Metro North-West Joint Development Assessment Panel Agenda

Meeting Date and Time: 29 November 2017; 2:30pm
Meeting Number: MNWJDAP/192
Meeting Venue: City of Joondalup
90 Boas Avenue
Joondalup

Form 1 – Responsible Authority Report (Regulation 12)

Property Location:	Lot 1 (248) Camberwarra Drive, Craigie
Development Description:	Child Care Centre
DAP Name:	Metro North-West JDAP
Applicant:	Planning Solutions
Owner:	The Roman Catholic Archbishop of Perth
Value of Development:	\$2,100,000.00
LG Reference:	DA17/0495
Responsible Authority:	City of Joondalup
Authorising Officer:	Dale Page, Director Planning and Community Development
DAP File No:	DAP/17/01210
Report Due Date:	17 November 2017
Application Received Date:	5 May 2017
Application Process Days:	90 days
Attachment(s):	1: Location plan 2: Development plans 3: Original perspective drawings 4: Amended perspective drawings

01 Site Context Plan 1:200 @ A1

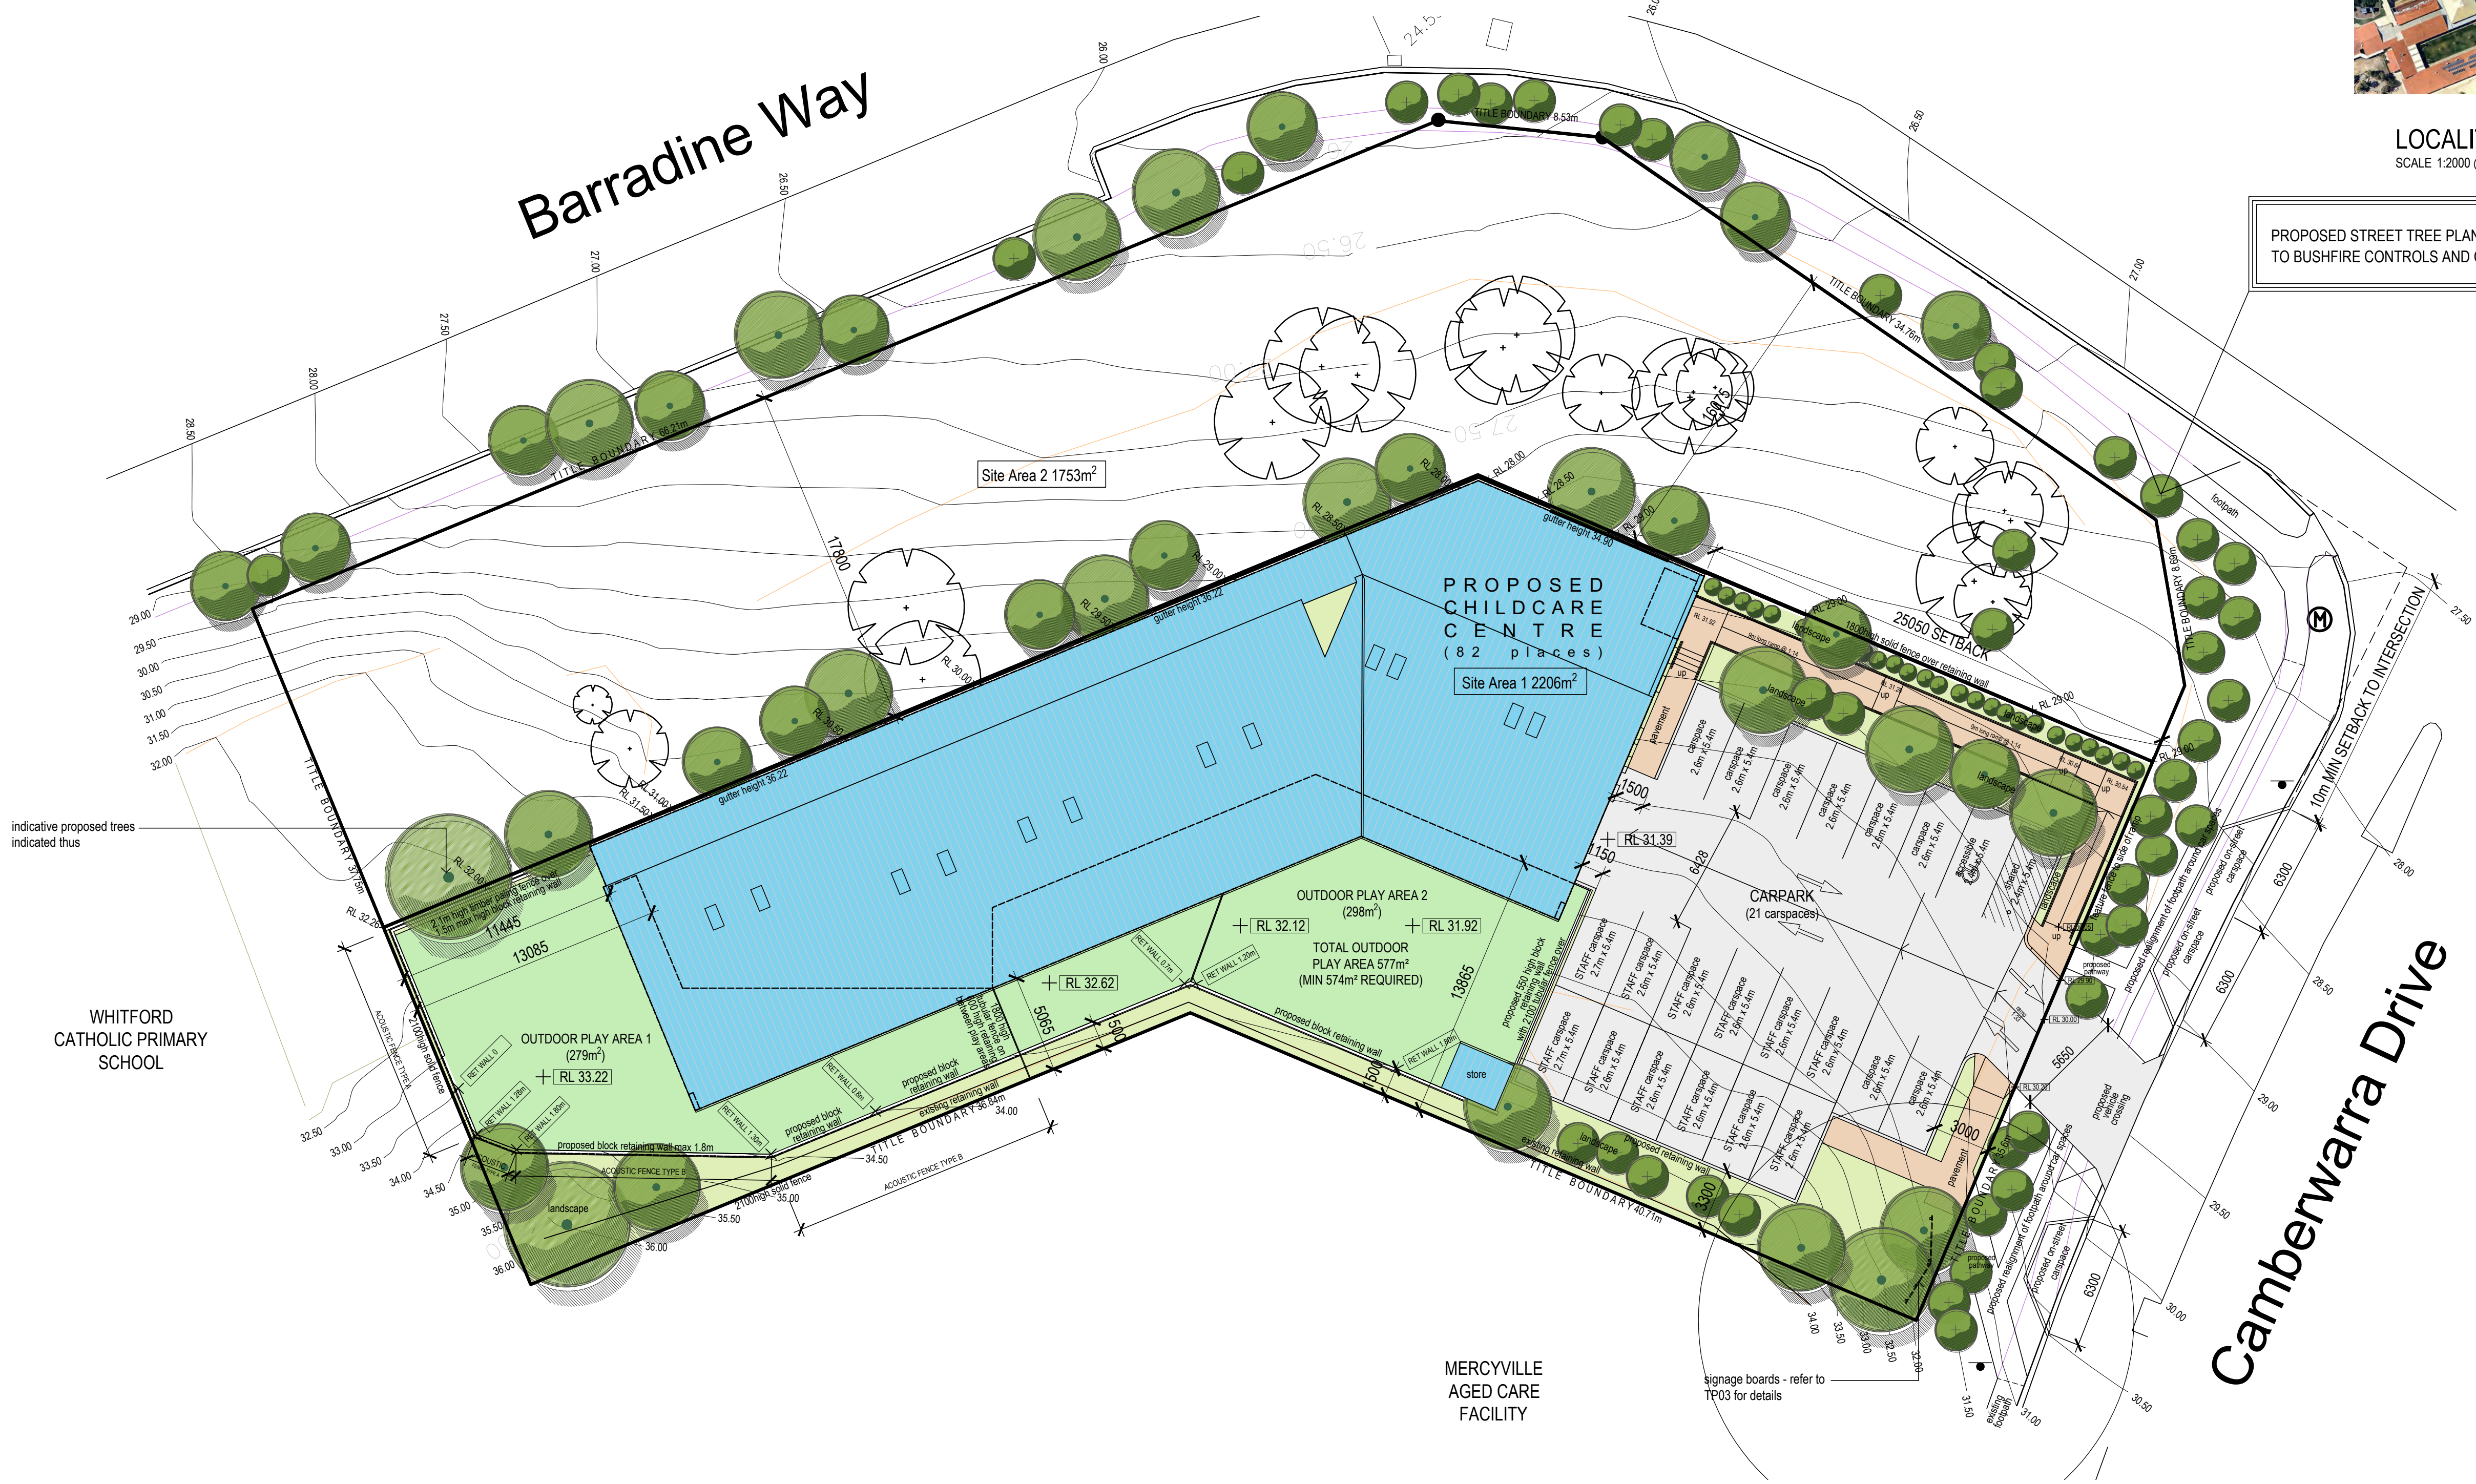
In accordance with clause 4.12 of DPS2, a three-metre landscaping strip is required between a car parking area and the street. The intent of this provision is to include vegetation to provide a green buffer which improves the streetscape and subsequently softens the building's appearance from the street.

The proposed development includes a three-metre setback from the car parking area to the Camberwarra Road street boundary, however the majority of this landscaping strip is occupied by a pedestrian footpath, leaving approximately 0.8 metres for the planting of vegetation. Due to the reduced landscaping strip, it is not possible to plant any significant vegetation and therefore the proposal does not achieve the intent of this provision.

As a result, the proposed development lacks appropriate landscaping space to enable the planting of vegetation which will improve the streetscape and therefore does not comply with clause 4.12 of DPS2.

DRAWING TITLE: **SECTIONS**
PROJECT: **Proposed Childcare Centre (82 places)**
ADDRESS: **248 Camberwarra Drive Craigie, Western Australia**
CLIENT: **TAL GP**

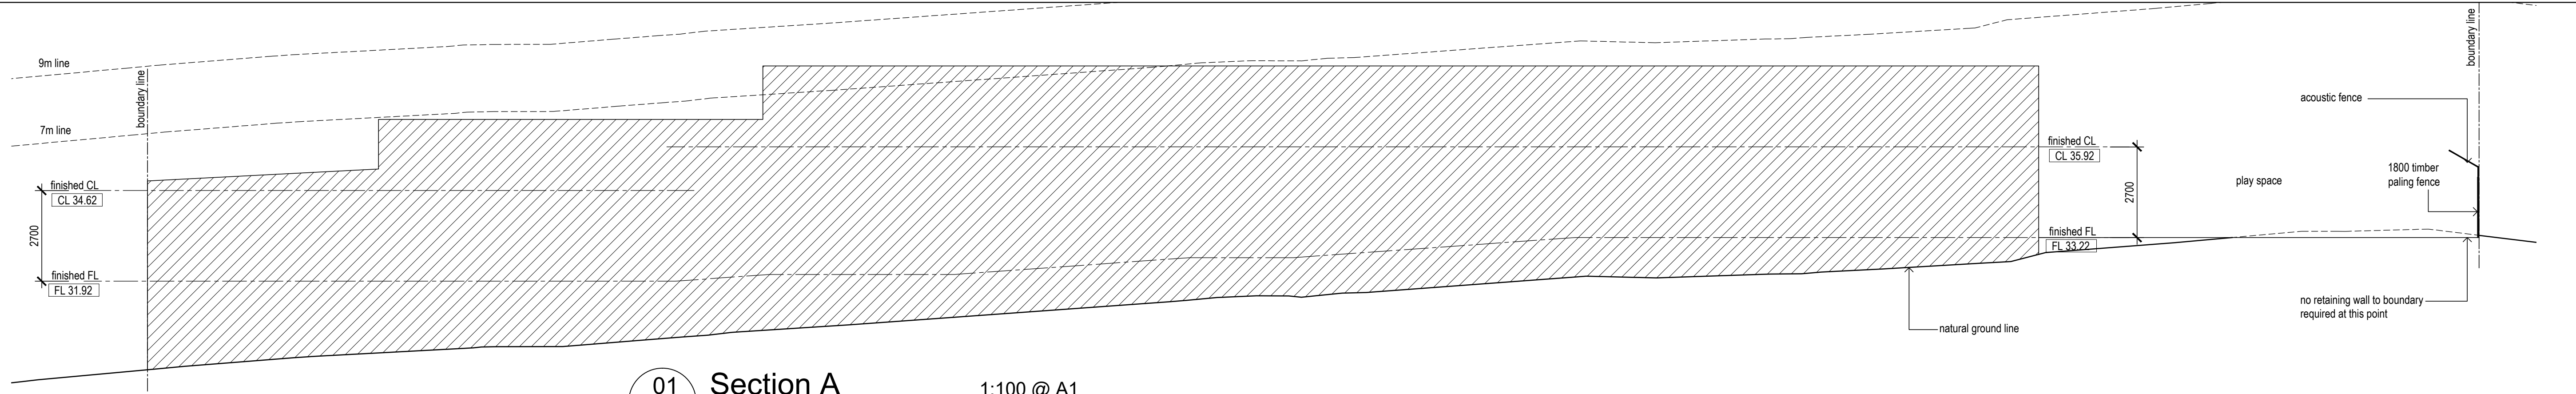
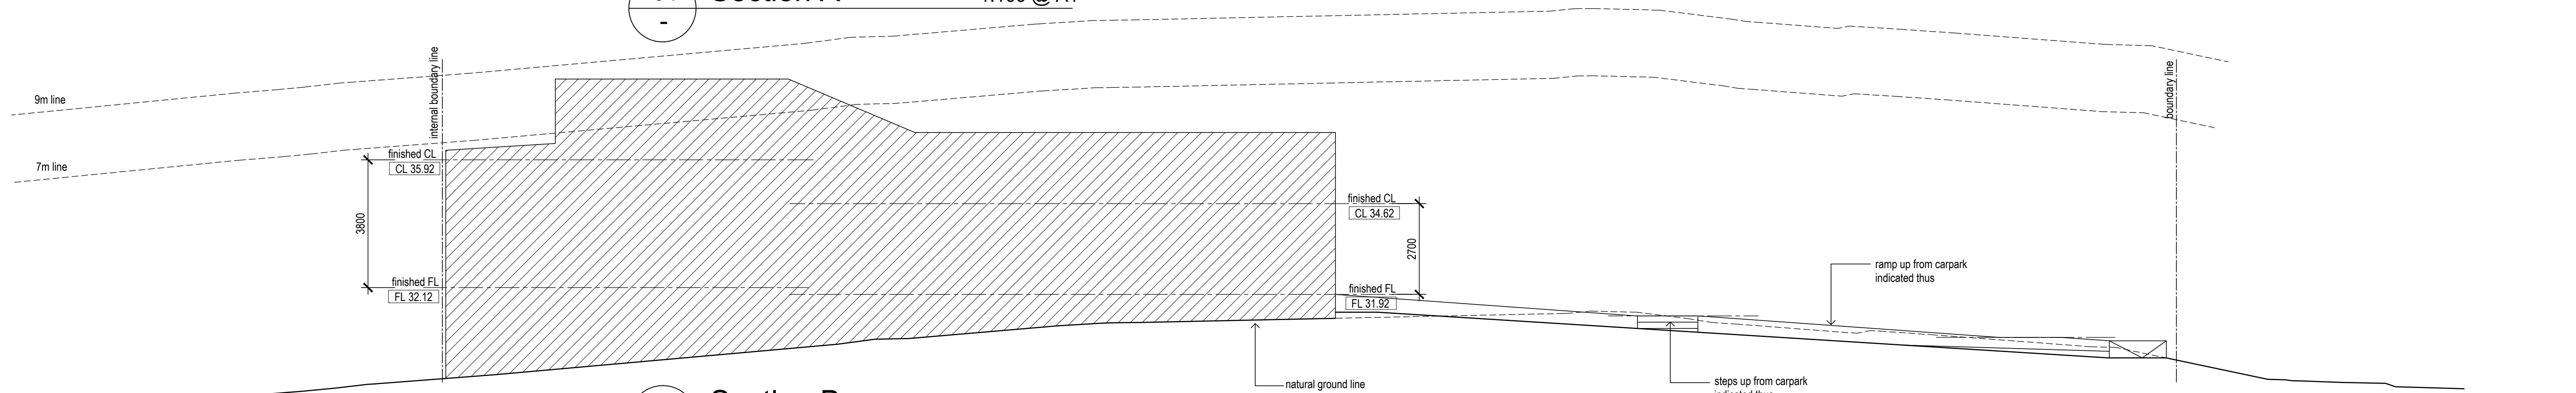
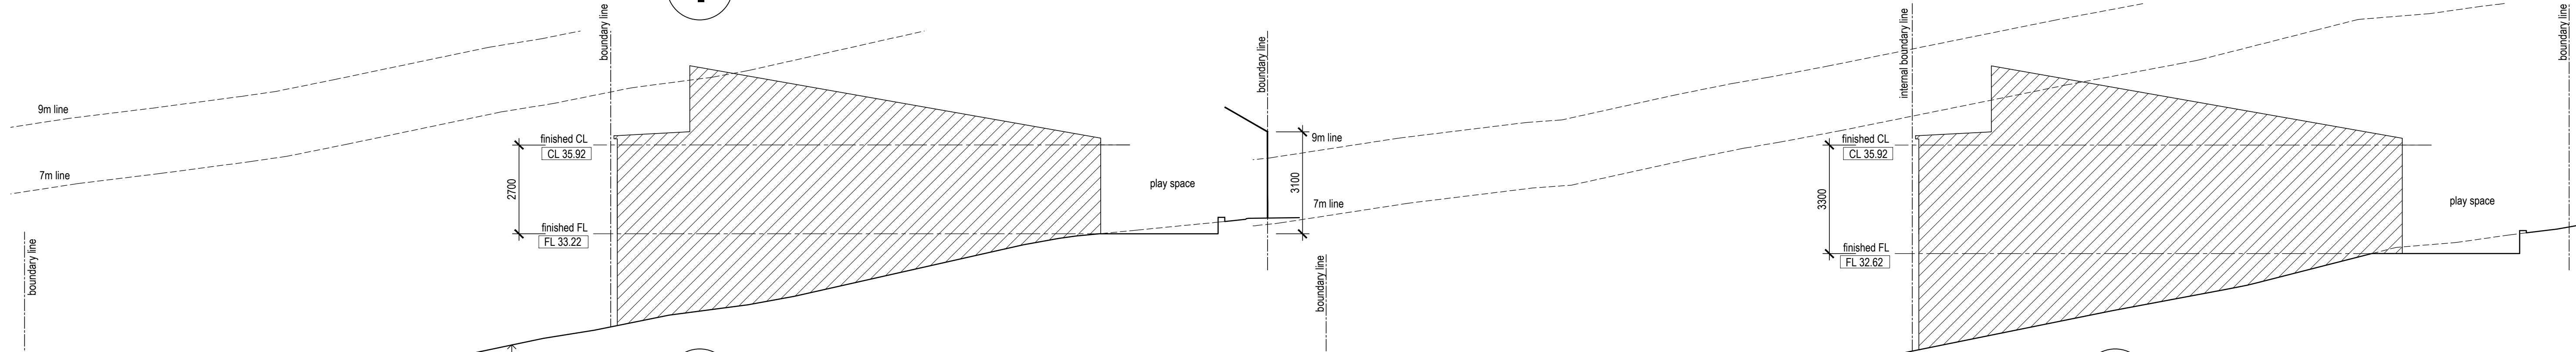
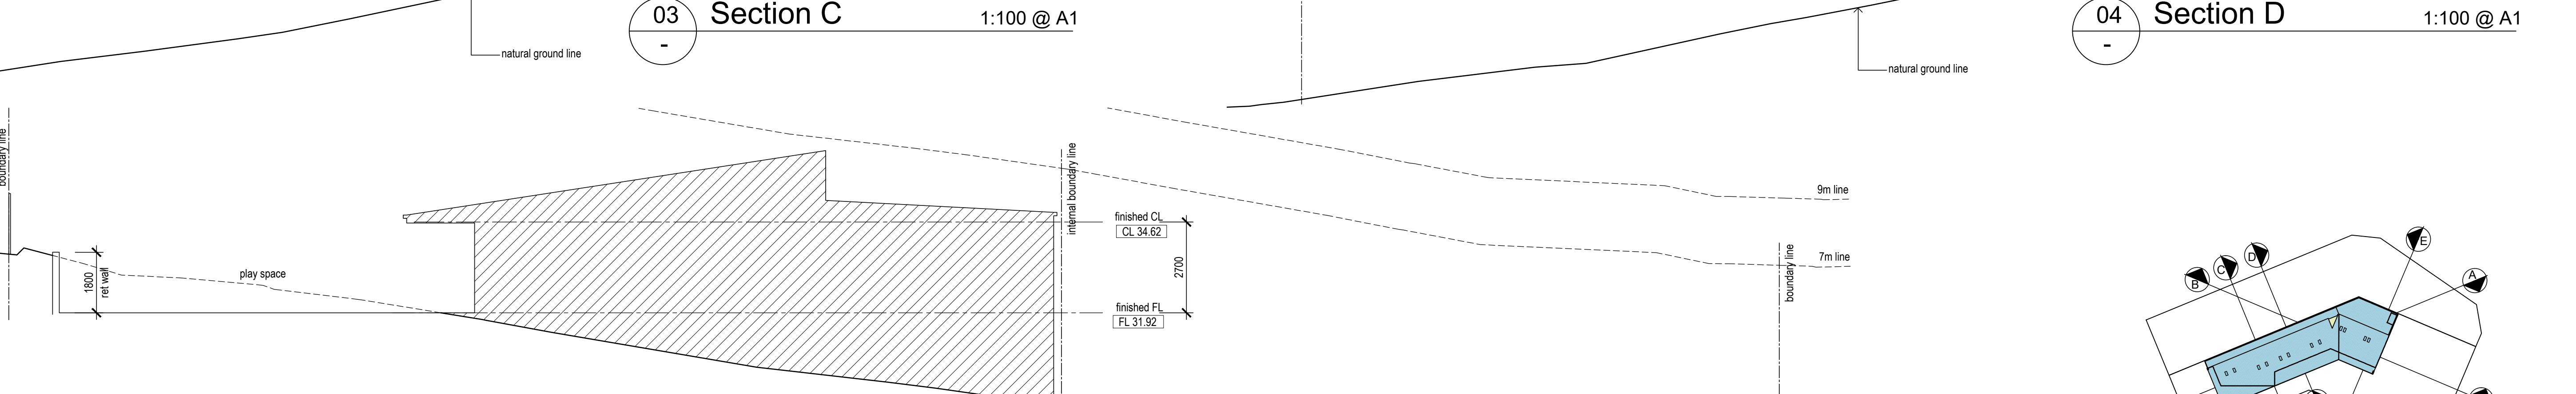
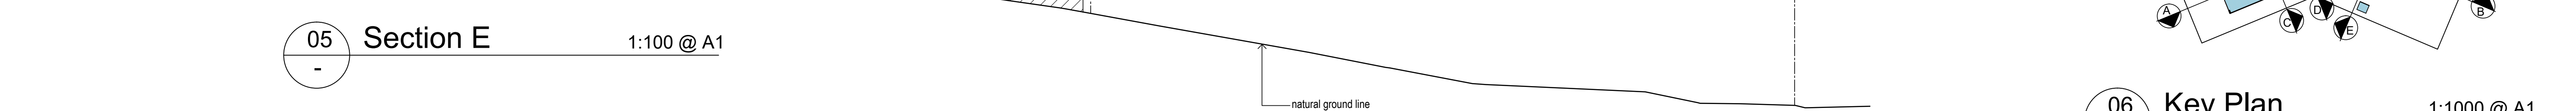
The lot slopes approximately ten metres from south to north, and the application proposes a level development site with no split levels contained internally and has selected a finished floor level consistent with the highest point of the site. The proposed development requires extensive site works resulting in significant retaining to the south and north of the building. As the development area within the lot has been limited by the applicant having to exclude the northern portion of the lot, there is no room to provide a development that respects the natural topography of the site. As a result, the building is proposed on top of the northern retaining wall, resulting in

In addition to the above, the proposed development includes a maximum concealed external wall height of 7.5 metres from natural ground level. Under Clause 6 of the City's Height of Non-Residential Buildings Local Planning Policy, the maximum permitted concealed wall height is seven metres.

The applicant has provided justification for the northern façade stating that the remaining portion of land will be developed with two-storey dwellings which will screen view of the wall from the street. In response to this statement, the City notes that the current zoning under DPS2 does not permit single houses or grouped dwellings on the subject site. The City's draft *Local Planning Scheme No. 3* (LPS3) may allow for this type of development in the future, however LPS3 is yet to be gazetted by the Western Australian Planning Commission (WAPC) and therefore there is no certainty that this will be permitted in the future. Additionally, there is no certainty as to when the remaining portion of the site will be developed, and there are no restrictions associated with this site which would require the landowner (or future landowners) to develop two-storey dwellings. The other concern is the liveability of future residents living in a dwelling adjoining this wall, as it will have a significant impact on the design, amenity and functionality of any dwelling adjacent.

4 East Elevation
Scale 1:100

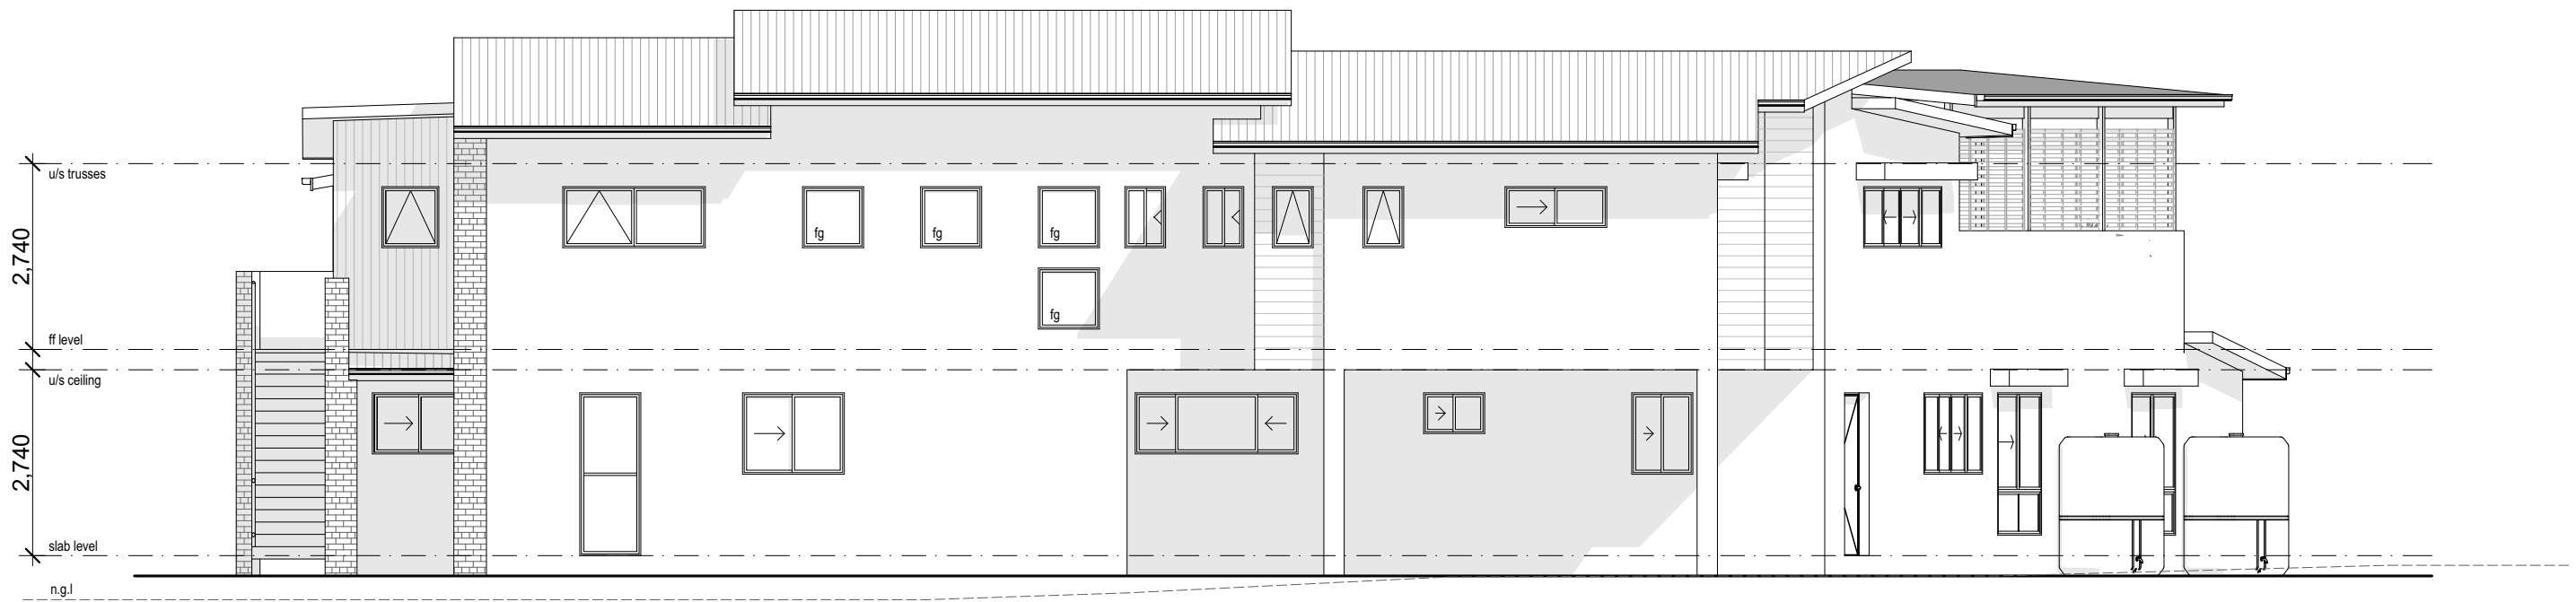
It was a recommendation of the JDRP that additional glazing and shading devices be incorporated into the eastern façade of the building to maximise surveillance of the car park. The applicant has provided amended plans including a vertical window on the ground floor foyer. It is considered that the additional window included improves surveillance of the car park. Additional awnings/ shading devices above openings are recommended as a condition of approval.

12. The eastern elevation of the building shall be modified to include awnings/shading devices above openings. Details of the awnings/shading devices shall be submitted to the City for approval prior to commencement of development. Development is to occur in accordance with these approved details.
